FMB110 Product Change Notifications

[Main Page](#) > [Advanced Trackers](#) > [FMB110](#) > **FMB110 Product Change Notifications**

Product change notifications (PCN) is the way of informing customers of upcoming changes related to Teltonika products. This includes outward appearance adjustments, hardware improvements, firmware changes, changes to package contents, etc. This page stores information regarding changes to the FMB110 tracking device. Below you will find a list of both upcoming and already implemented changes sorted from newest to oldest (top to bottom).

2021.01.01: Top Laser Printing Changes

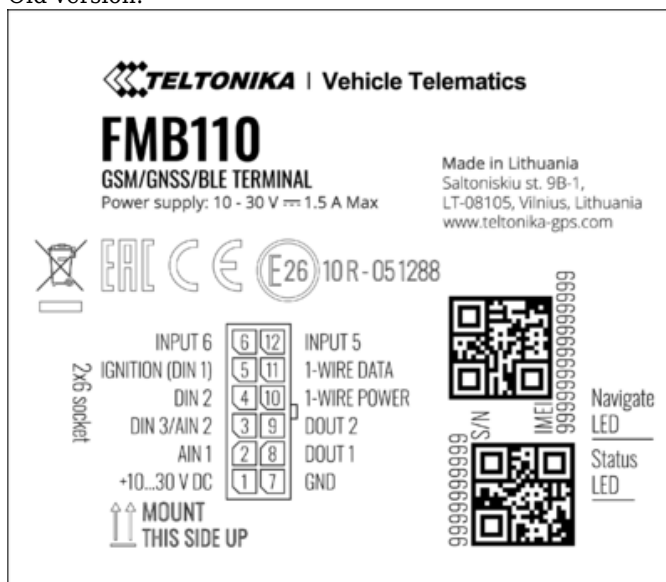
Change type	External/visual
	Top laser printing design changed
	Old version:

Change reasons	1. Updated Emark certificate number. 2. Added UKCA label. 3. Updated Teltonika brand to Teltonika Telematics.
----------------	---
